January 7, 2019

RE: **Hollywood Hills Plaza Outparcel – 4,500 S.F. Commercial Building**
Hollywood, Florida
File # 18-DP-34

Below are our responses to the City's comments for the above referenced project:

WATER AND SEWER PLAN

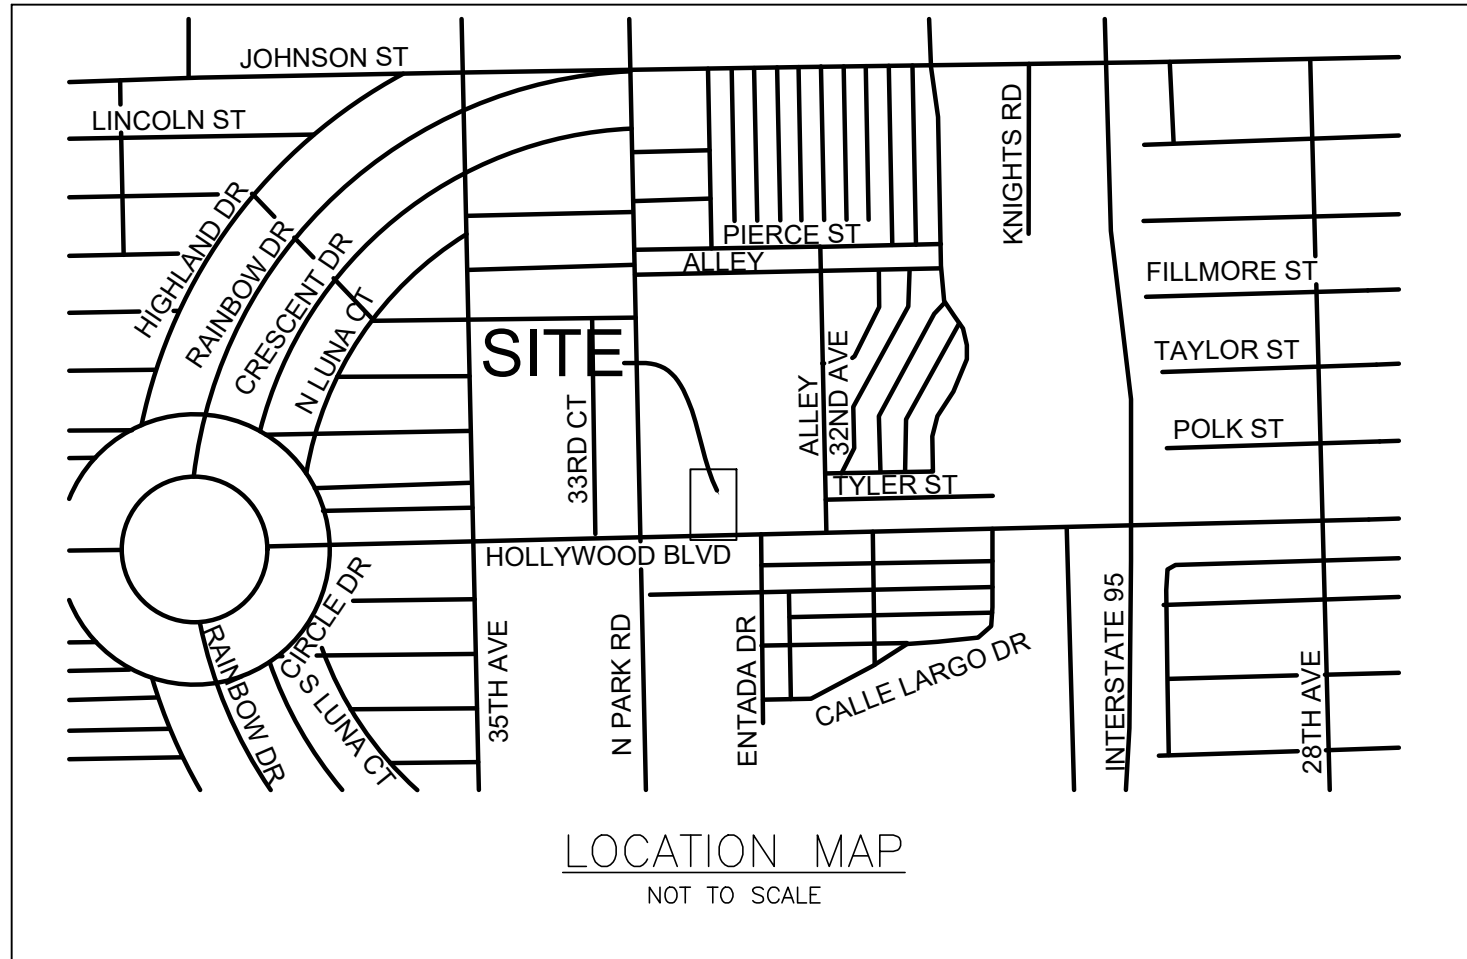
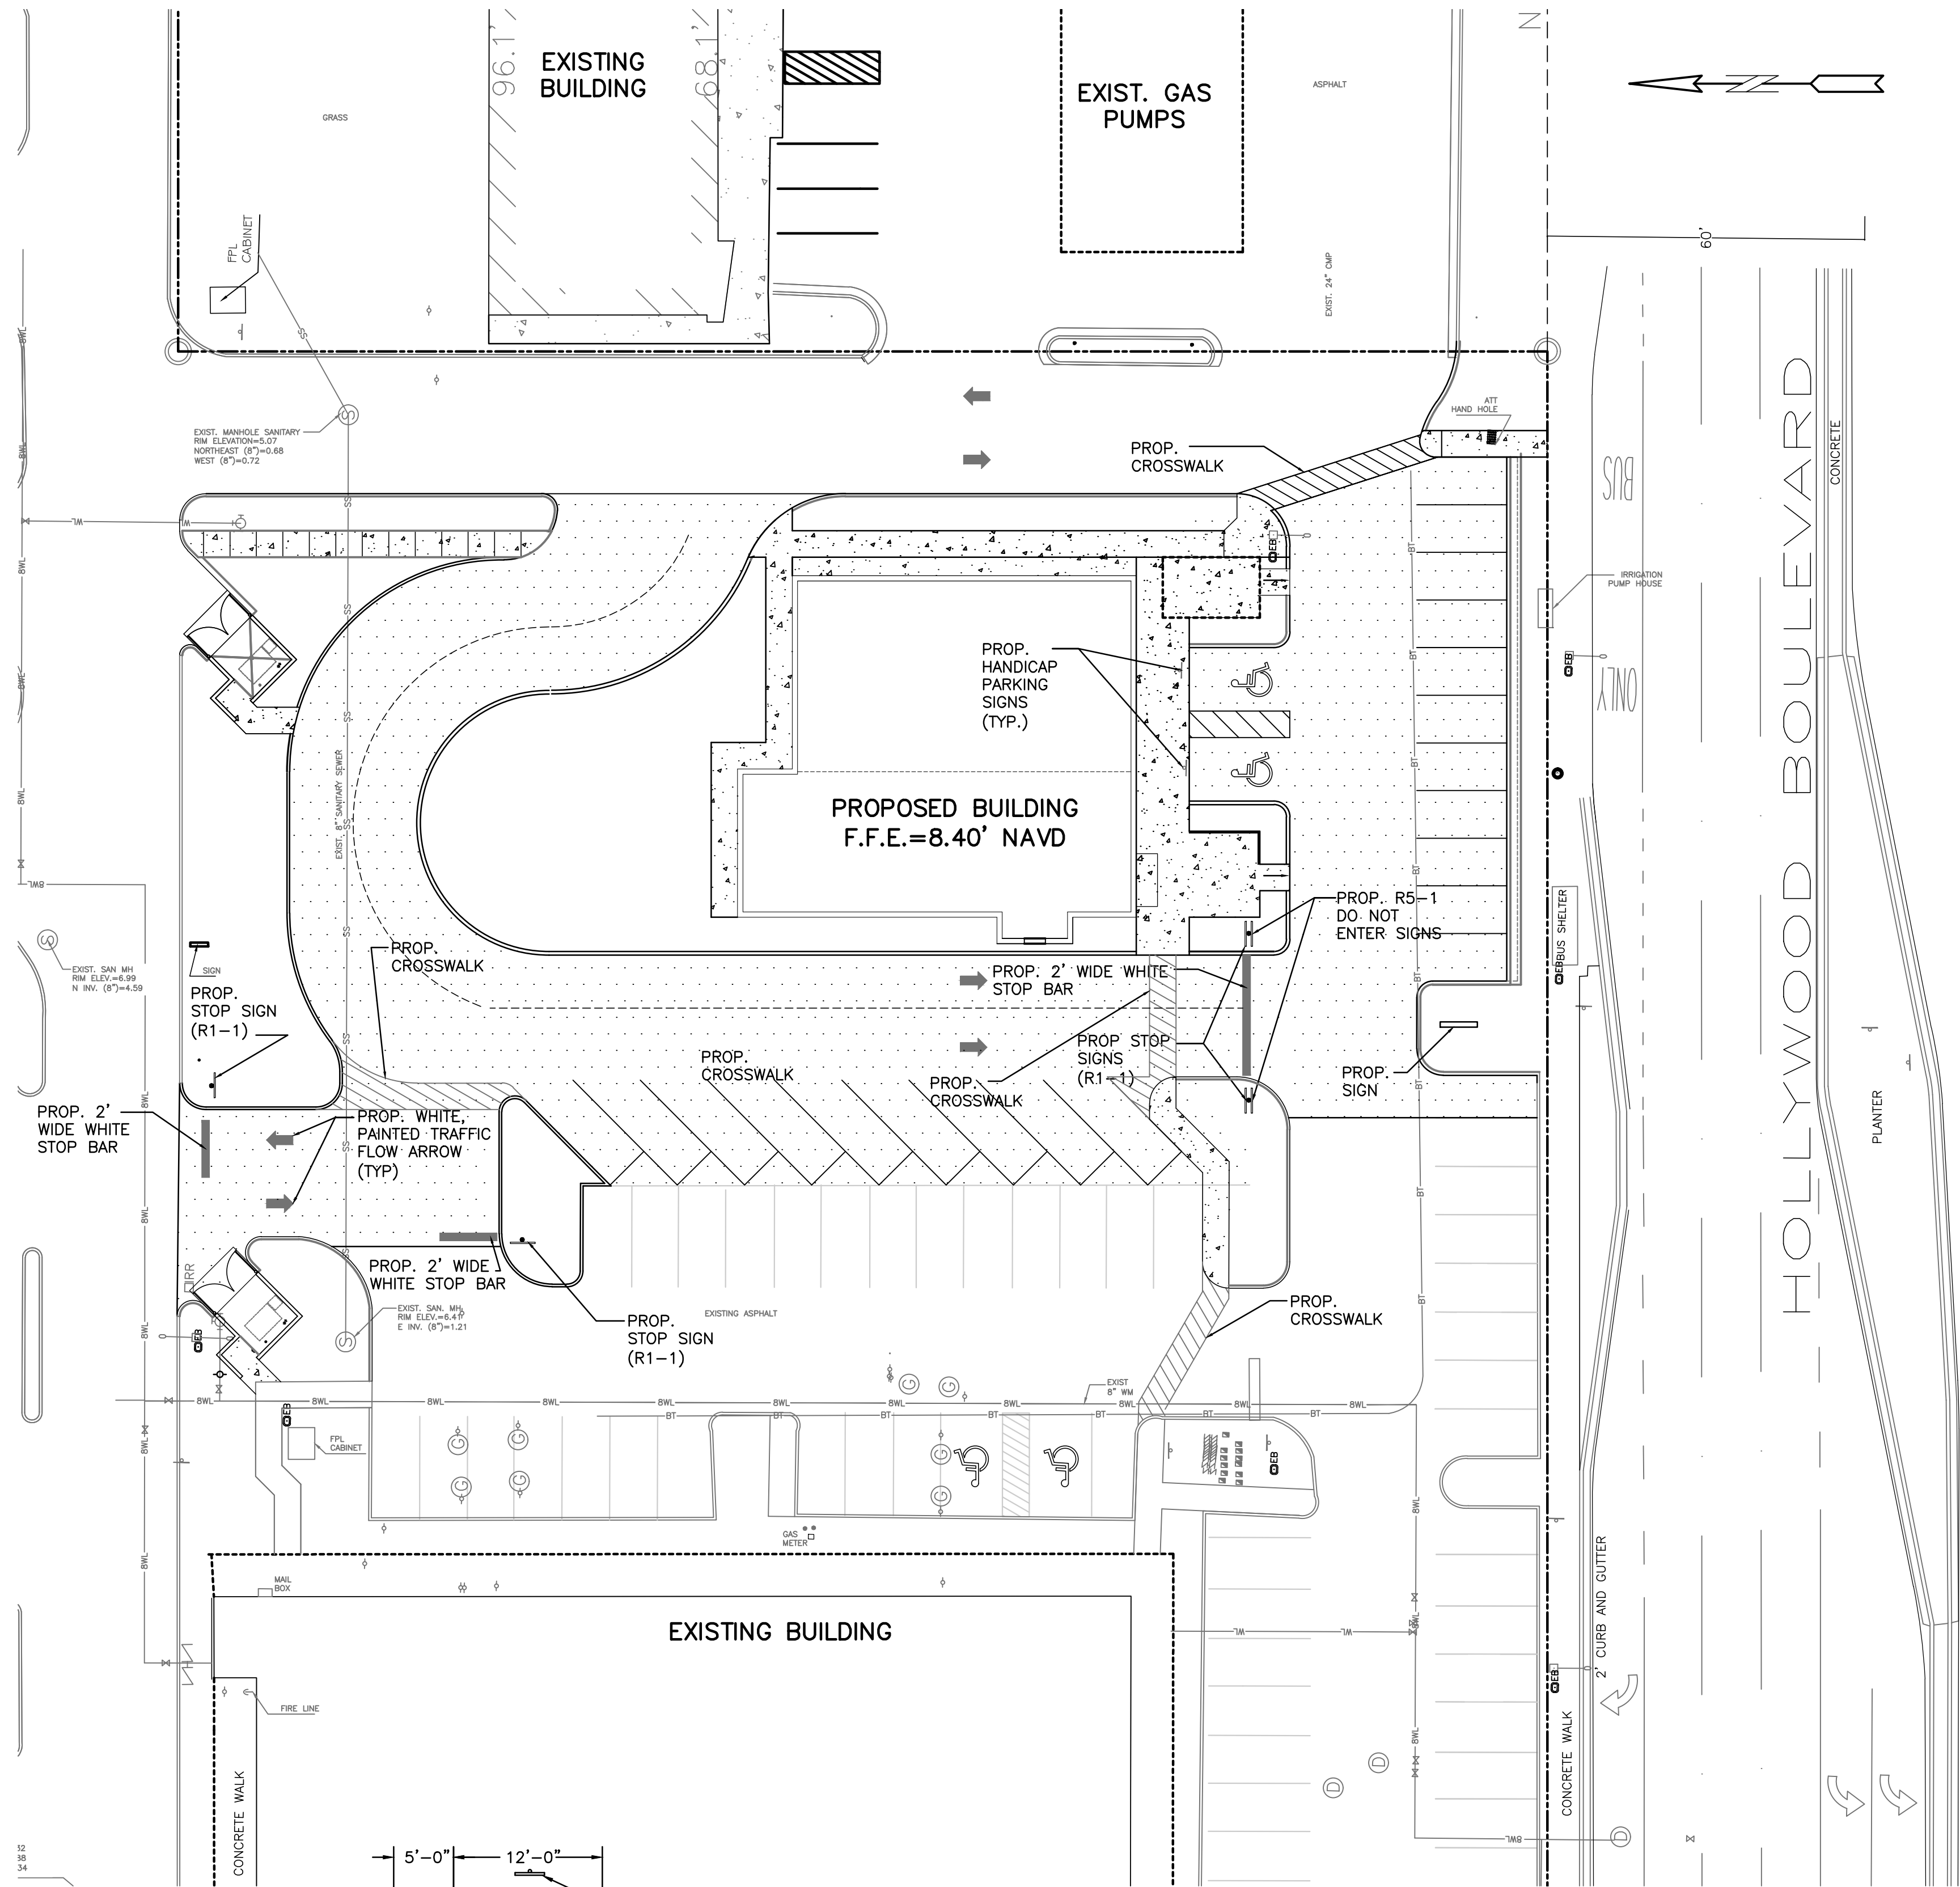
- minimum fire flow requirements.
- Response:** *These items will be provided.*
2. Comment: Two fire hydrants are shown, on civil drawings SP1.0 with one relocated. If more hydrants are required, please show the location including where the relocated hydrant will be placed.

- Response:** *The existing hydrant was relocated just west of its current location. Please refer to C-2.*
3. Comment: Is it possible to relocate the hydrant shown behind the dumpster? It's not the best location. Although it is the minimum 5' width from the dumpster, it's hidden by the dumpster and would be subject to vehicular damage every time the dumpster is emptied.

sheet title:
existing tree
plan

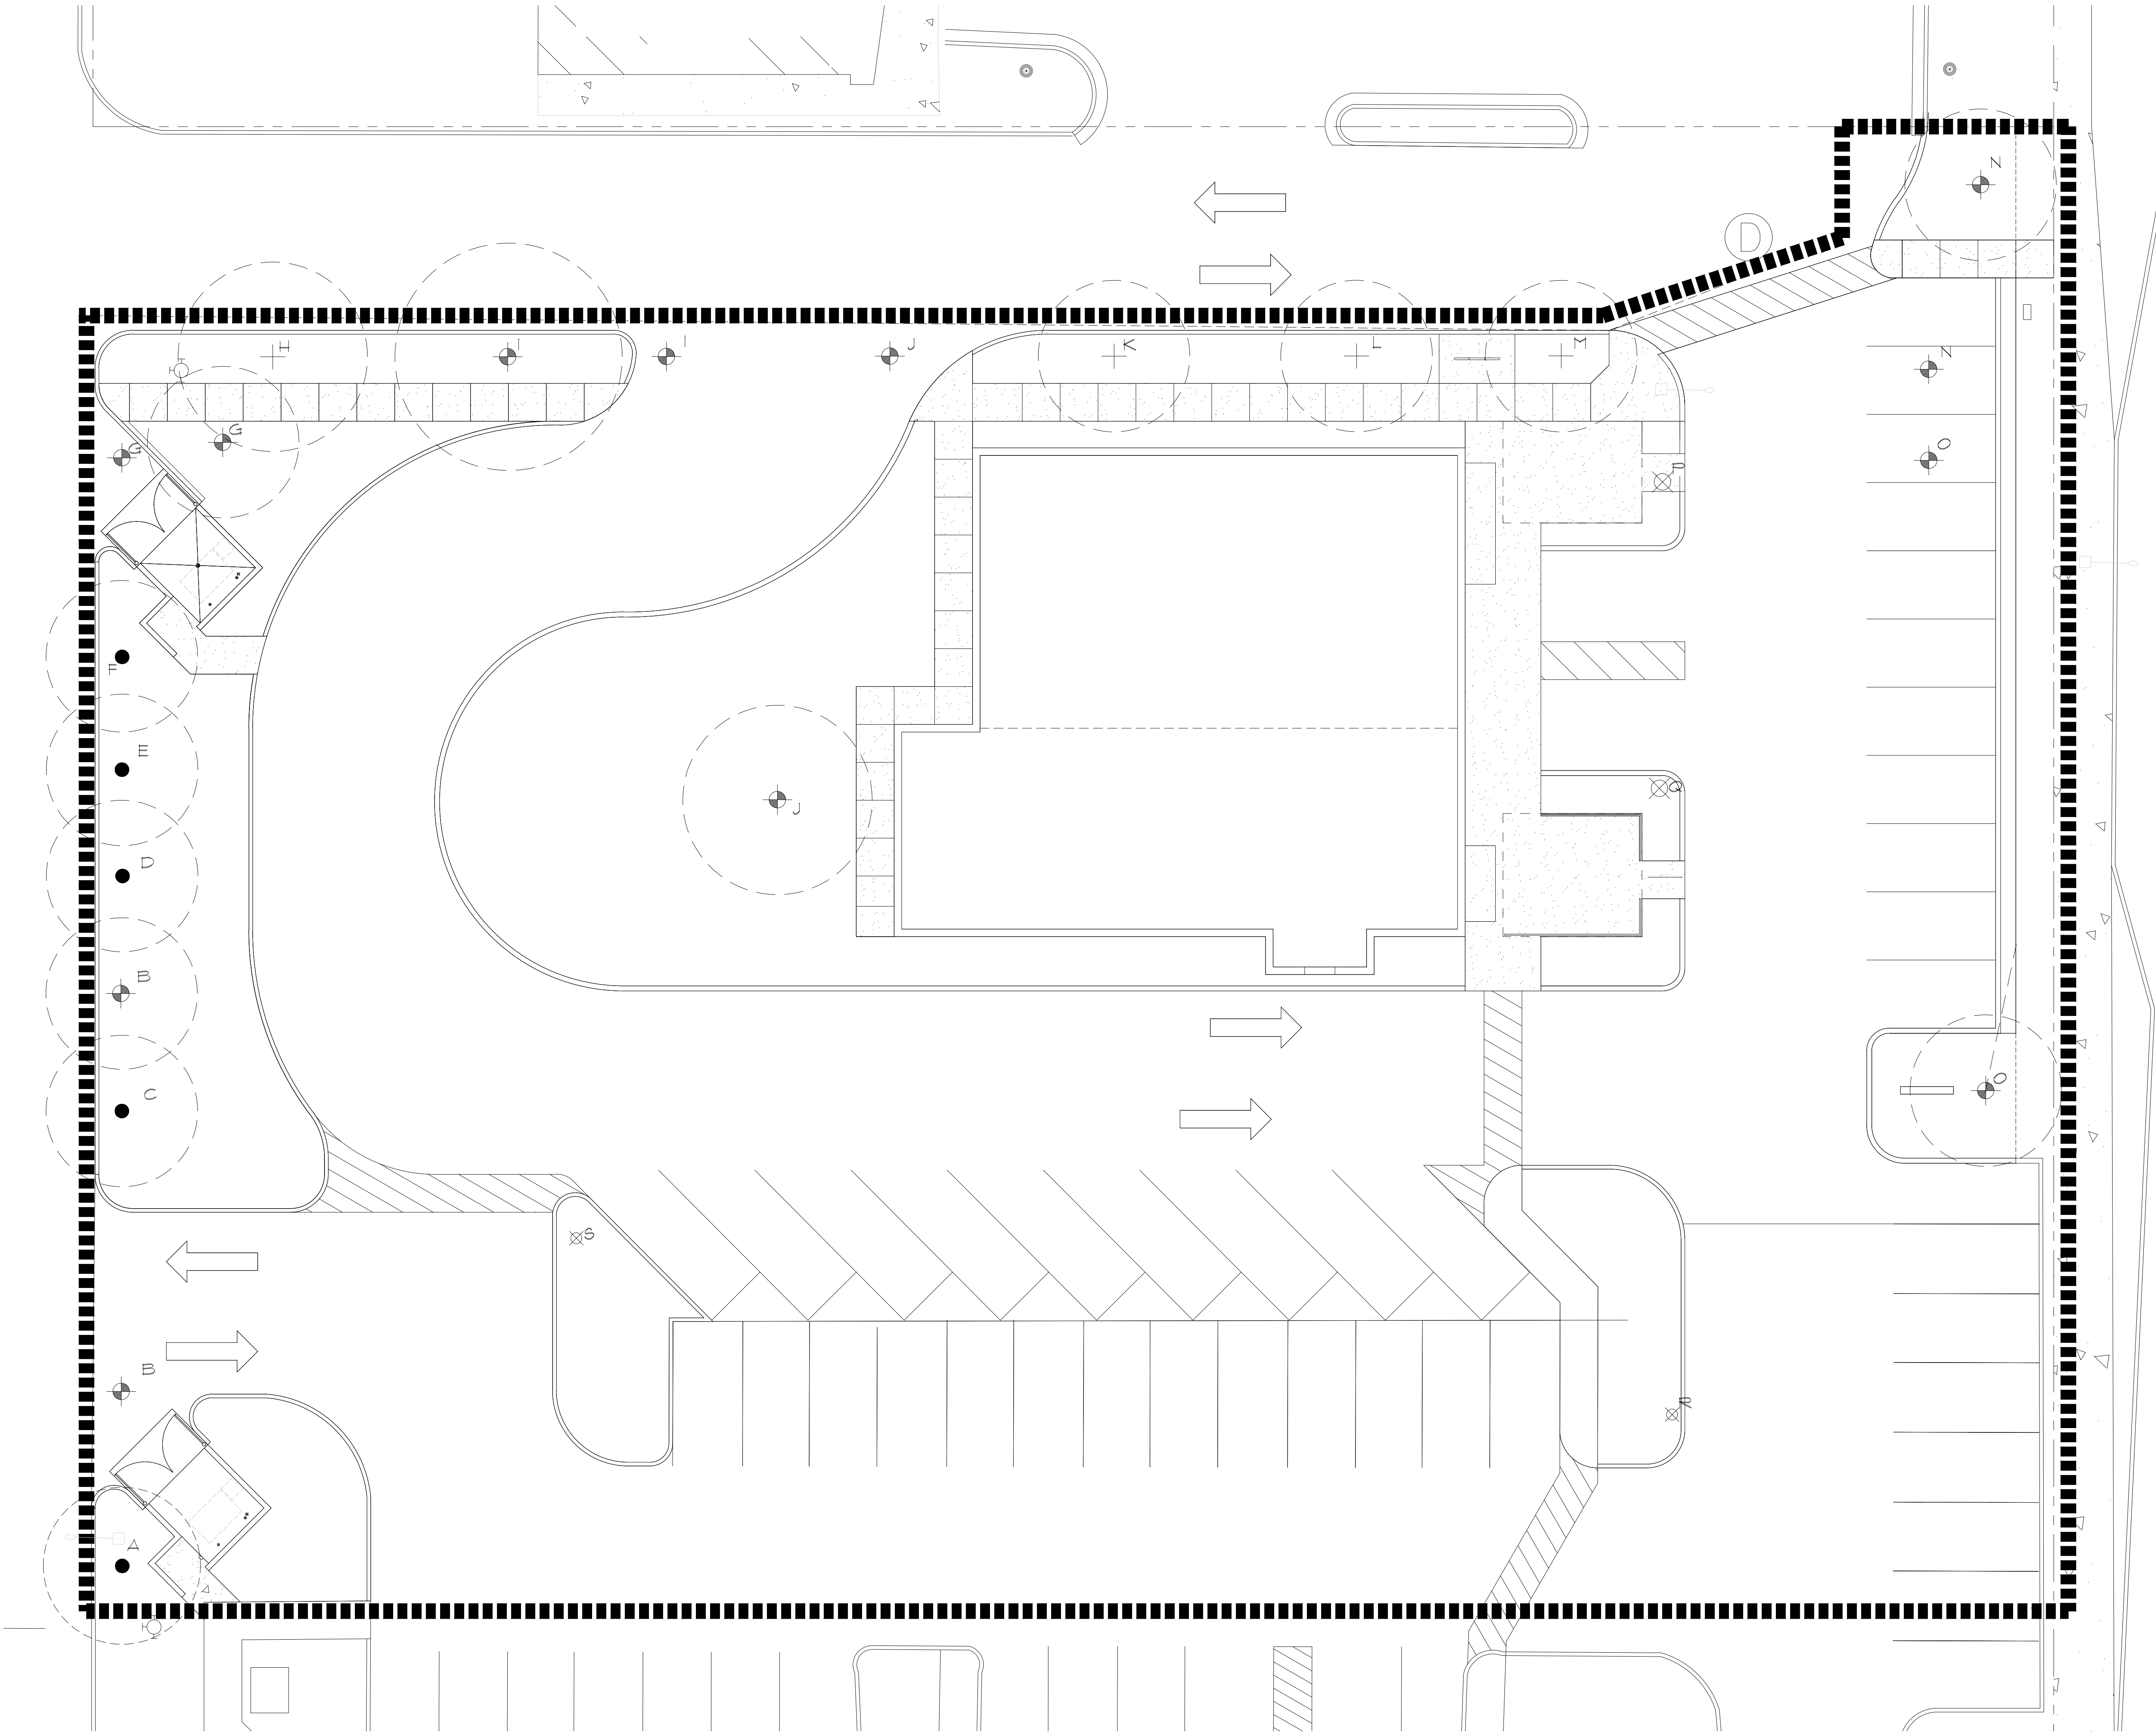
1. Comment: Provide a separate sheet with a tree disposition plan in a larger scale showing the trees proposed to remain, relocate and to be removed.

3. Comment: Explain and clarify as part of the notes on the L-1 sheet that mitigation that cannot be met on site will be mitigated via tree trust fund contribution or by providing larger trees/DBH on site.

Response: *A separate sheet has been provided to show the tree disposition at a larger scale. See sheet L-1.*
